From: [Adam Osbekoff](#)
To: [Jeremiah Cromie](#)
Subject: RE: SE-22-00053 KC Flood Control Zone District - Notice of Application
Date: Thursday, June 2, 2022 3:35:19 PM

RE: SE-22-00053 KC Flood Control Zone District
I-90 Exit 74, West Nelson Siding Road.

Re: SEPA Register 202202745, SE-22-00053

SUBJECT: SE-22-00053 KC Flood Control Zone District

Channel & Road Profile

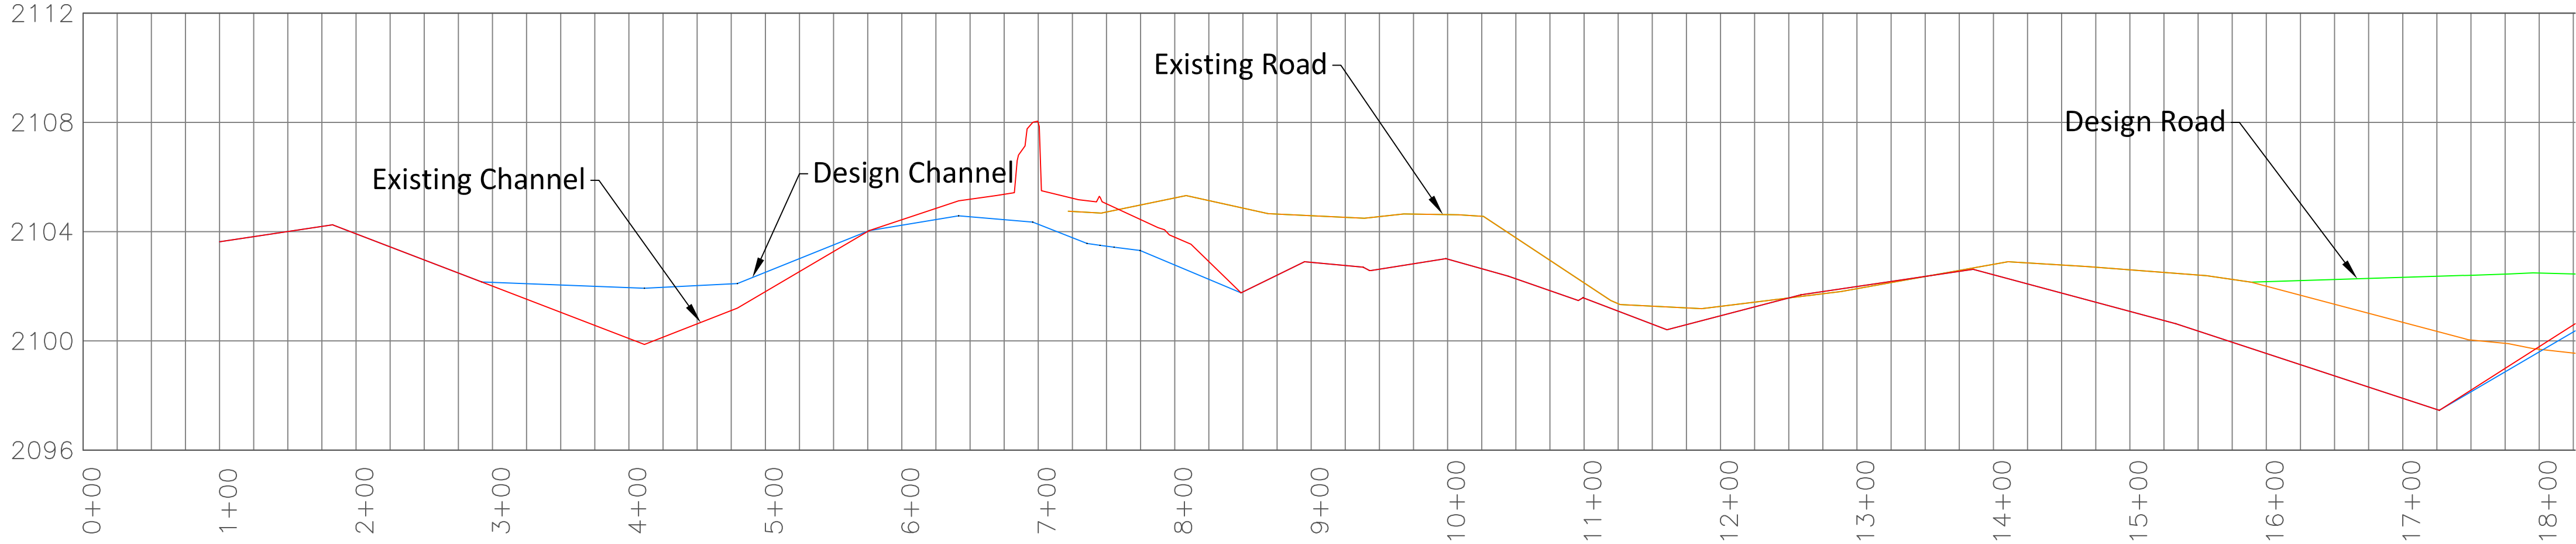
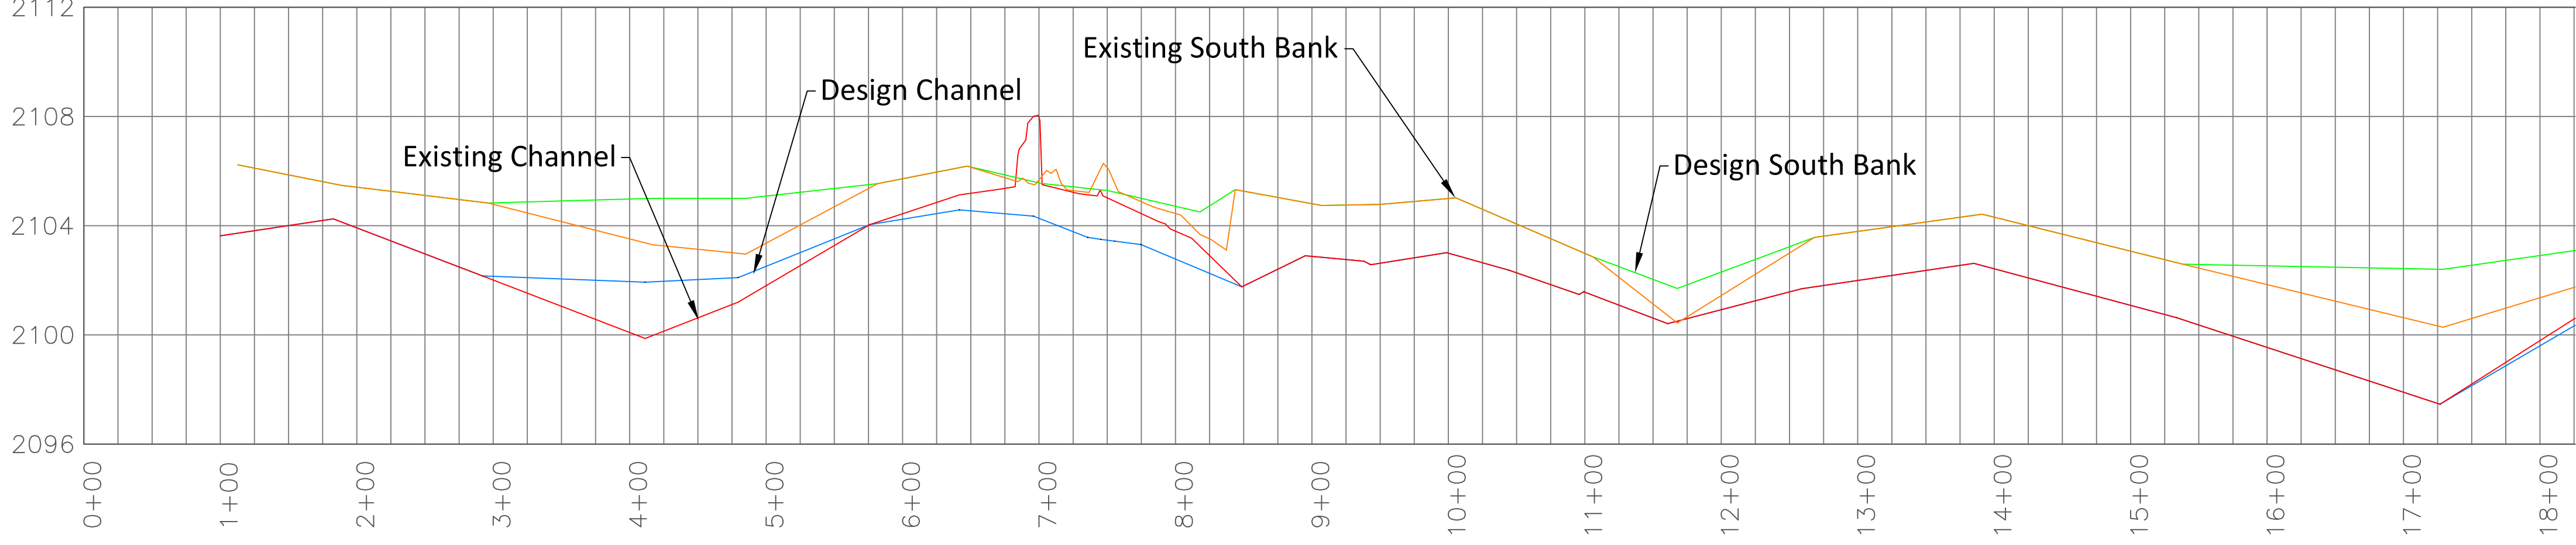
I attach an elevation profile (KittitasCounty_DraftPlans.pdf) that we received from Kittitas County a couple years ago, after we met with County engineers at this site. My concern is that the existing (unpermitted) adjacent road is consistently at a higher elevation than the proposed drainage ditch, which will make most of the work by Kittitas County a complete waste of time. Flood waters cannot reach the proposed improvements due to the impervious surface labelled "Existing Road" on attached document.

I request details of the County plan, showing how flood waters can ever even reach the proposed improvements. Most likely that would require installation of culverts under the "Existing Road" which crosses State Park property.

I attach an elevation profile (KittitasCounty_DraftPlans.pdf) that we received from Kittitas County a couple years ago, after we met with County engineers at this site. My concern is that the existing (unpermitted) adjacent road is consistently at a higher elevation than the proposed drainage ditch, which will make most of the work by Kittitas County a complete waste of time. Flood waters cannot reach the proposed improvements due to the impervious surface labelled "Existing Road" on attached document.

I request details of the County plan, showing how flood waters can ever even reach the proposed improvements. Most likely that would require installation of culverts under the "Existing Road" which crosses State Park property.
